**ANSTY GARDEN COMMUNITY,**

**DESIGNERS RESPONSE**

**REPORT REF NO. 2207280-R17A**

<b>Report title:</b>	Designers Response to Stage 1 Road Safety Audit – A272 Proposed Toucan Crossing
<b>Date:</b>	May 2025
<b>Document reference and revision:</b>	2207280-R17A
<b>Prepared by:</b>	Ardent Consulting Engineers
<b>On behalf of:</b>	Fairfax Acquisitions Ltd

Drawing Number **2207280-010** Rev **C**

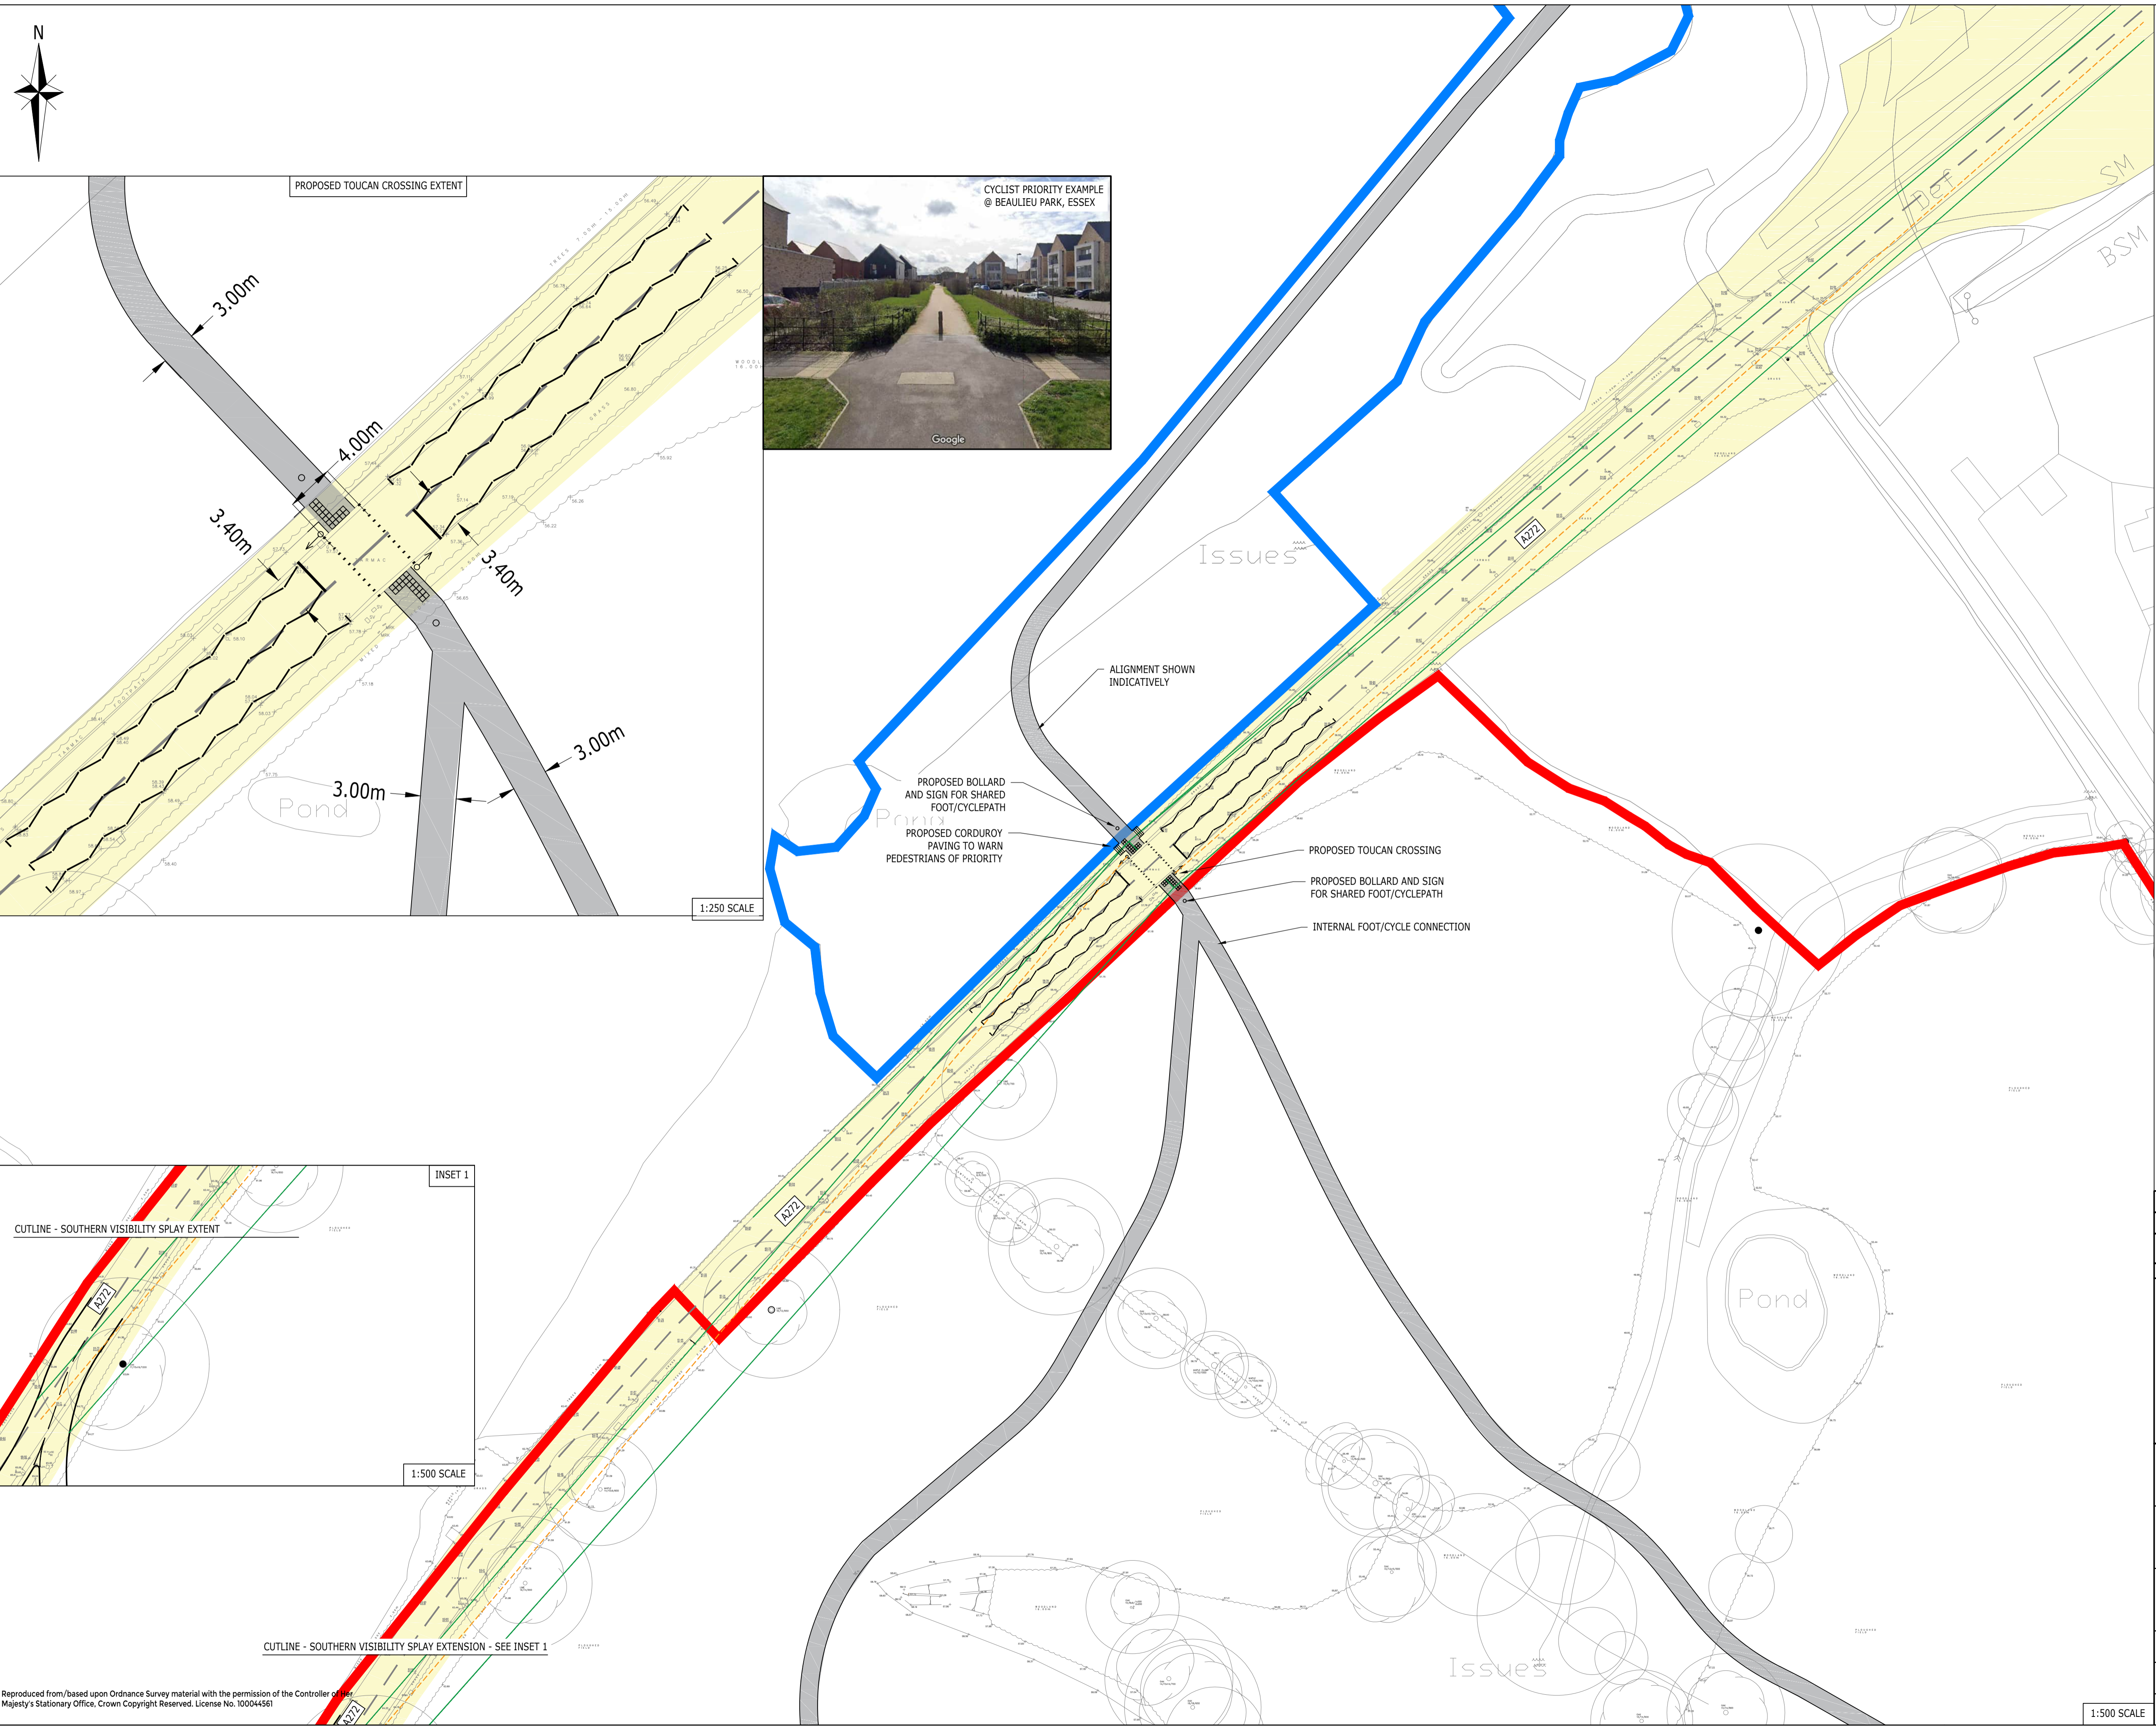
<p>3.1.2 Inappropriate surfacing could lead to vehicle to pedestrian / cyclist collisions or rear end shunts.</p> <p>The proposals do not include the introduction of anti-skid surfacing or a surface with a high polished stone value (PSV) on the approaches to the crossings. Surfacing with an inadequate PSV could lead to vehicles not being able to stop, leading to possible rear end shunt or vehicle to pedestrian / cyclist collisions.</p>	<p>It is recommended that antiskid surfacing or surfacing with a high PSV should be used on the approaches to the crossings.</p>	<p>Agree. Details of PSV values and surfacing materials will be provided for Stage 2 Audit.</p>	<p>High friction surfacing should be provided and details of PSV values to be provided at detailed design stage.</p>	<p>High friction surfacing to be provided and details of PSV values to be provided at detailed design stage.</p>
<p>3.1.3 Excessive speed on approaches to signals could lead to vehicle to pedestrian / cyclist collisions or rear end shunts.</p> <p>No traffic survey information was provided for assessment, where a National speed limit applies on the A272 at this location. Excessive speeds on the approaches to the Toucan crossing may affect the safe operation of the crossings and could lead to vehicles not being able to stop, leading to possible rear end shunts, or vehicle to pedestrian / cyclist collisions.</p>	<p>It is recommended that the 85th percentile speeds should be checked to see if speed discrimination equipment is required, further with the associated development taking place in the surrounding area that the nature of the area is changing, and a reduced speed limit should be installed.</p>	<p>Disagree. The proposed roundabout will significantly change the nature of speeds approaching the proposed crossing location, resulting in lower than compared to the current speeds</p> <p>Visibility splays for the current posted speed has been shown and noted to be kept clear to be robust at this stage.</p> <p>A change in speed limit is at the discretion of WSCC but as presented, the design incorporates suitable visibility splays based on the current posted speed limit.</p>	<p>A speed limit reduction is essential for the acceptability of the signalised crossing and would be support by officers including the head of road safety.</p> <p>The need for discrimination equipment to be considered at detailed design</p>	<p>TRO change to be progressed in liaison with WSCC and speed discrimination equipment to be considered for RSA2.</p>

<p>could lead to sudden braking and rear end shunt collisions or vehicle to pedestrian collisions.</p>				
<p>3.5.2 Length of zig zag controlled area could lead to vehicle to pedestrian/cycle collisions.</p> <p>The zig-zag controlled area is the standard 8 zig zags. This length of zig-zags may provide insufficient warning of the crossing on a high speed road and could lead to failure to stop and vehicle to pedestrian collisions.</p>	<p>It is recommended that the zig-zags should be extended on the approaches.</p>	<p>Agree. The proposed road markings for the toucan crossing have been updated as per safety audit recommendations and TSRGD standards. These are shown on <b>ACE Drawing 2207280-010C</b>.</p>	<p>Length of zig zags have been extended on the drawing.</p>	<p>No further action at this stage.</p>
<p>3.5.3 Positioning of stop lines could lead to vehicle to pedestrian collisions.</p> <p>The stop lines could be too close to the pedestrian crossings. This may cause a vehicle to stop at inappropriate locations and may also reduce the intervisibility with pedestrians who are crossing, particularly children, which could lead to vehicle to pedestrian collisions.</p>	<p>It is recommended that the stop line markings should be set back a minimum of 2.5m from the stud lines.</p>	<p>Agree. The proposed road markings for the toucan crossing have been updated as per safety audit recommendations and TSRGD standards. These are shown on <b>ACE Drawing 2207280-010C</b>.</p>	<p>Road markings have been updated on the drawing.</p>	<p>No further action at this stage.</p>

As per recommendations it has been noted on <b>ACE Drawing 2207280-010C</b> that speed discrimination equipment to be considered if required (to be presented for RSA2).		
<p>3.4.1 Restricted visibility could lead to side impact or rear end shunt collisions.</p> <p>No intervisibility splays for pedestrians or forward visibility splays to signal heads has been supplied for assessment. Intervisibility splays for pedestrians and forward visibility to signal heads pass through areas of vegetation. Visibility could be restricted and this could lead to vehicle to pedestrian or rear end shunt collisions.</p>	<p>It is recommended that vegetation should be removed from the intervisibility splays, and forward visibility splays, and that a regular maintenance programme to retain the visibility splays should be employed. It is also recommended that the SSD should be supplied for assessment at Stage 2 Safety Audit</p>	<p>Agree. Visibility splays based on current posted speed limit have been shown to signal heads and from the proposed toucan crossing as shown on <b>ACE Drawing 2207280-010C</b>. Vegetation to be trimmed and cut back to keep visibility splays clear has also been noted on the drawing. Further details will also be provided for Stage 2 Audit.</p>	<p>Vegetation to be removed/trimmed back from visibility splays. Splays are shown on the latest drawings.</p>	<p>Visibility splays to be suitably maintained and kept clear.</p>

Rev	Description	Dn	Chk	App	Date
C	UPDATED FOLLOWING WSCC HIGHWAY COMMENTS	DV	DV	DH	26.02.24
B	UPDATED FOLLOWING STAGE 1 RSA COMMENTS	DV	DV	DH	17.10.23
A	PROPOSED CYCLE/PEDESTRIAN ROUTE SHOWN NORTHERN SIDE OF THE A272 TO BEECHY BOTTOM RESERVE	ADS	DH	KM	28.09.23

Plan attached showing the locations of the problems identified as part of this audit (location numbers refer to paragraph numbers in the report).

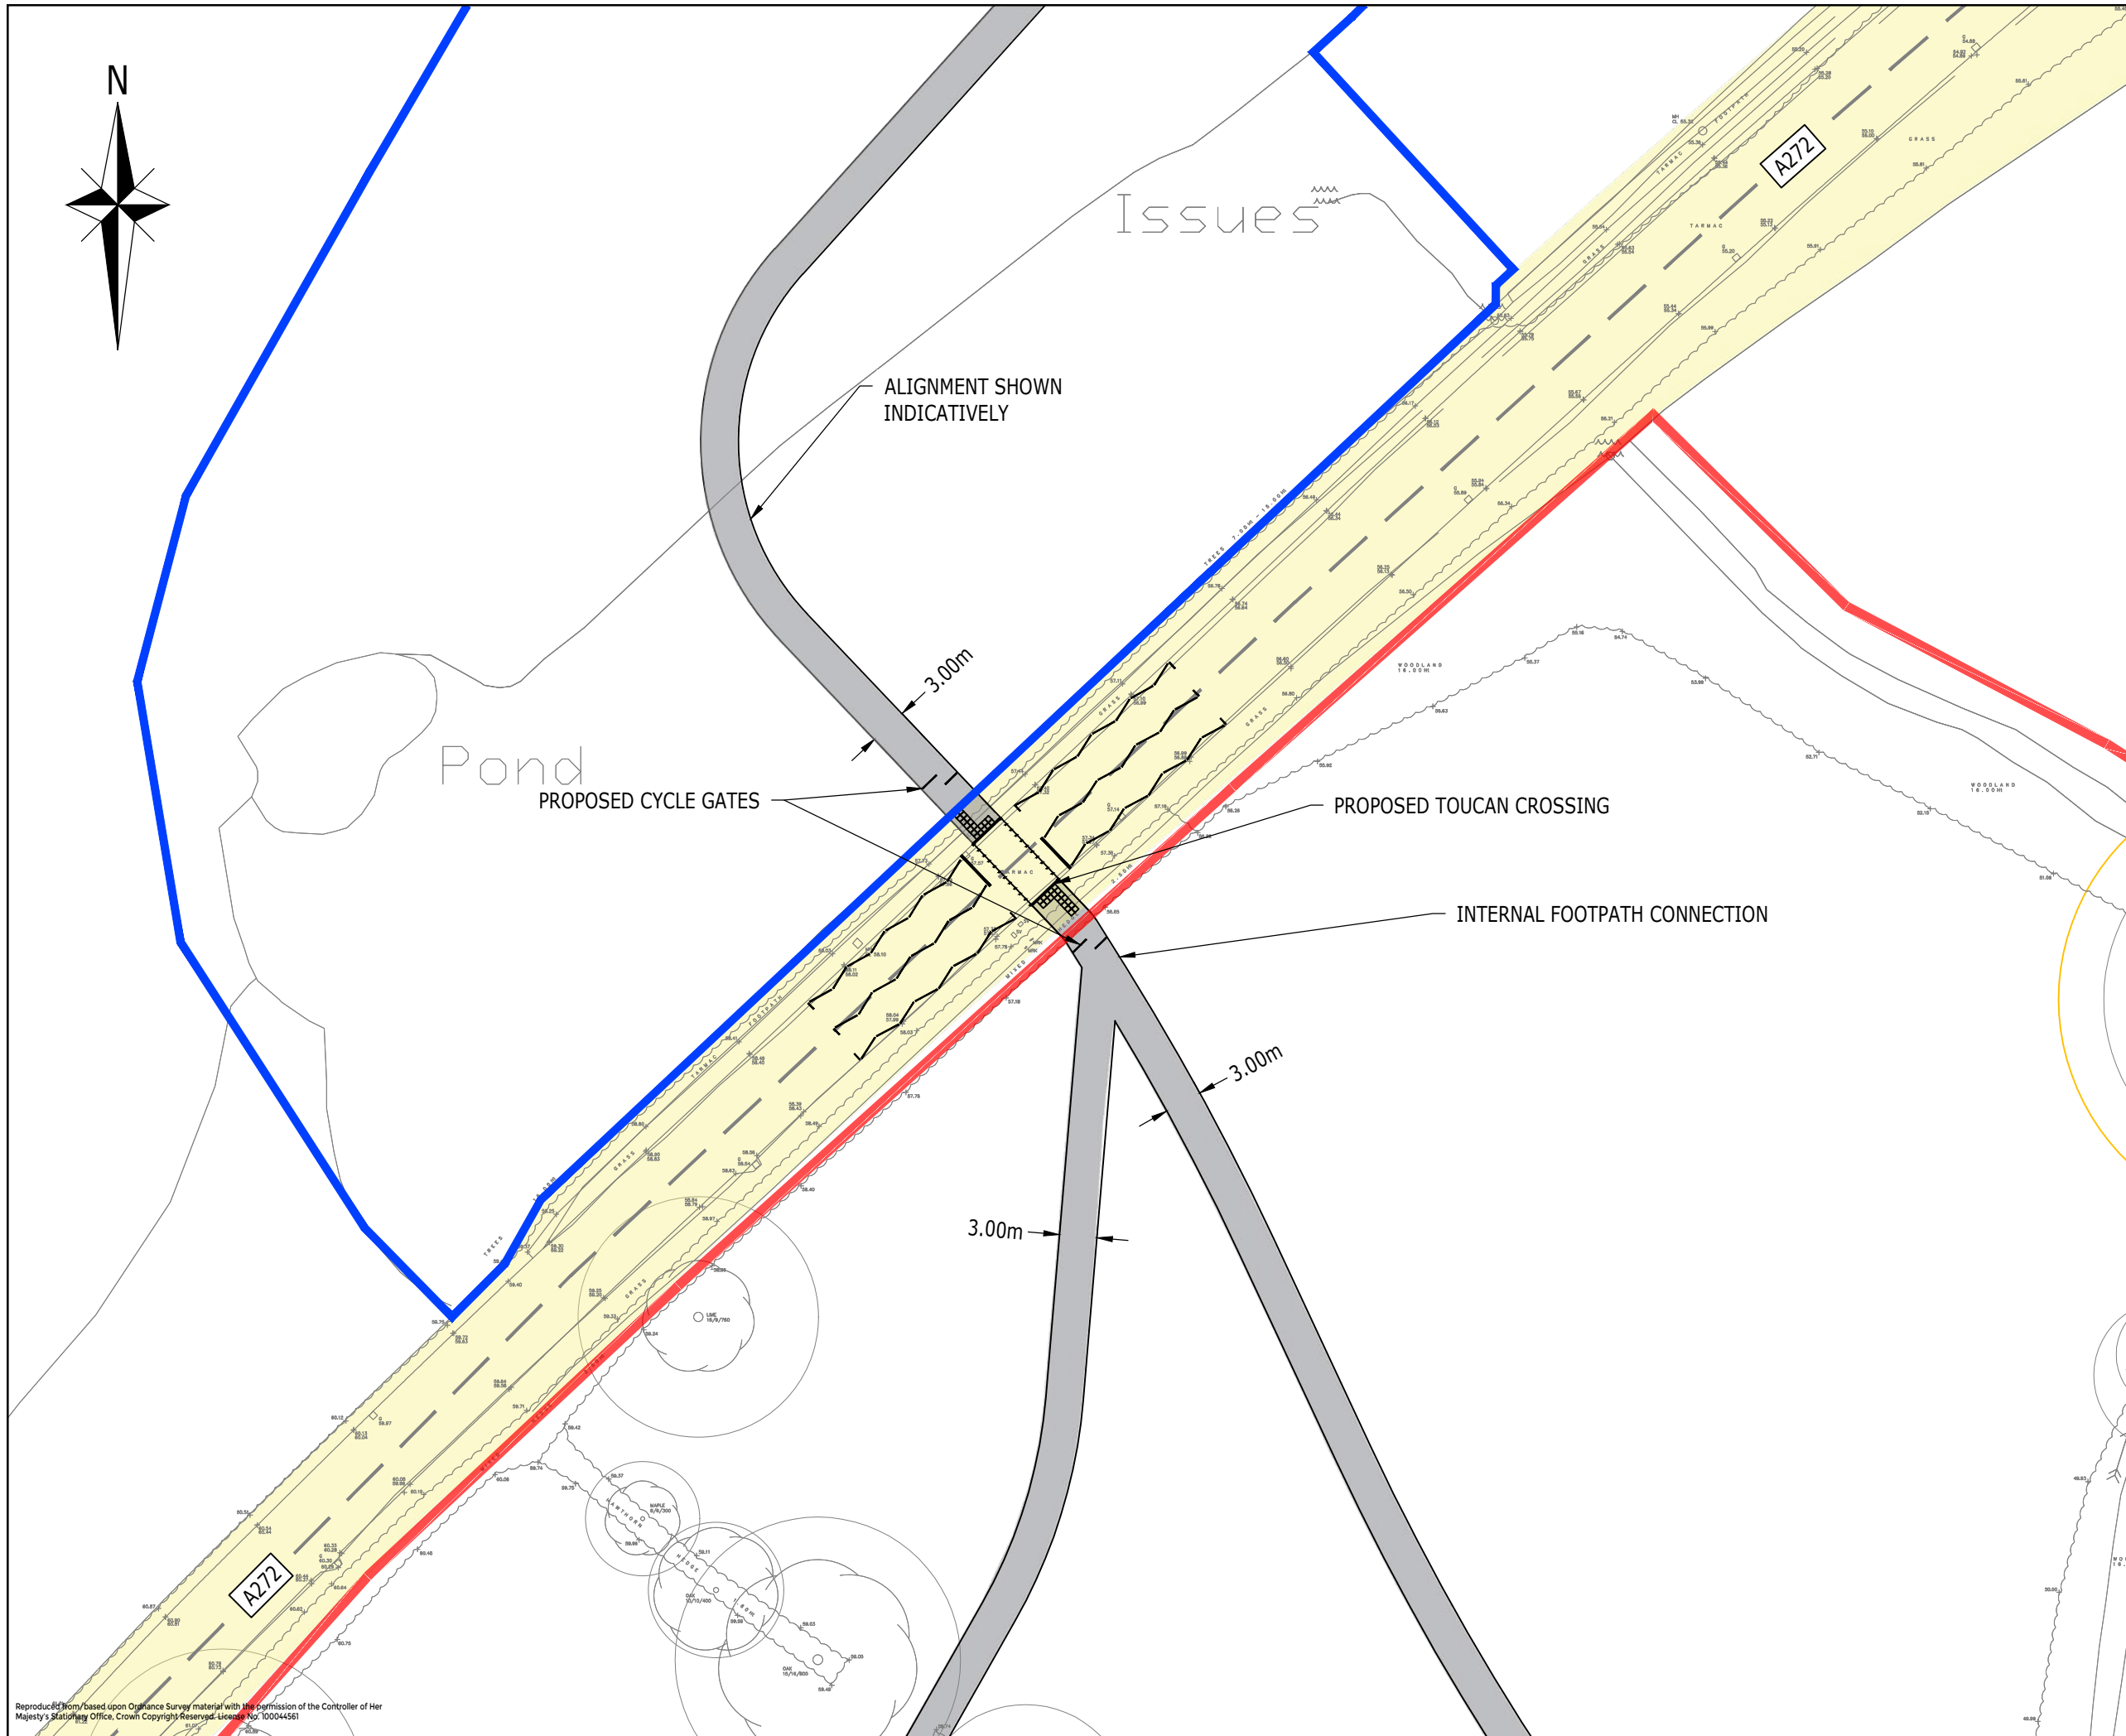
No traffic survey information was provided for assessment, where a National speed limit applies on the A272 at this location. Excessive speeds on the approaches to the Toucan crossing may affect the safe operation of the crossings and could lead to vehicles not being able to stop, leading to possible rear end shunts, or vehicle to pedestrian / cyclist collisions.

No intervisibility splays for pedestrians or forward visibility splays to signal heads has been supplied for assessment. Intervisibility splays for pedestrians and forward visibility to signal heads pass through areas of vegetation. Visibility could be restricted and this could lead to vehicle to pedestrian or rear end shunt collisions.

The zig-zag controlled area is the standard 8 zig zags. This length of zig-zags may provide insufficient warning of the crossing on a high speed road and could lead to failure to stop and vehicle to pedestrian collisions.

The stop lines could be too close to the pedestrian crossings. This may cause a vehicle to stop at inappropriate locations and may also reduce the intervisibility with pedestrians who are crossing, particularly children, which could lead to vehicle to pedestrian collisions.

It is recommended that the 85<sup>th</sup> percentile speeds should be checked to see if speed discrimination equipment is required, further with the associated development taking place in the surrounding area that the nature of the area is changing, and a reduced speed limit should be installed.

It is recommended that vegetation should be removed from the intervisibility splays, and forward visibility splays, and that a regular maintenance programme to retain the visibility splays should

It is recommended that the zig-zags should be extended on the approaches.

It is recommended that the stop line markings should be set back a minimum of 2.5m from the stud lines.
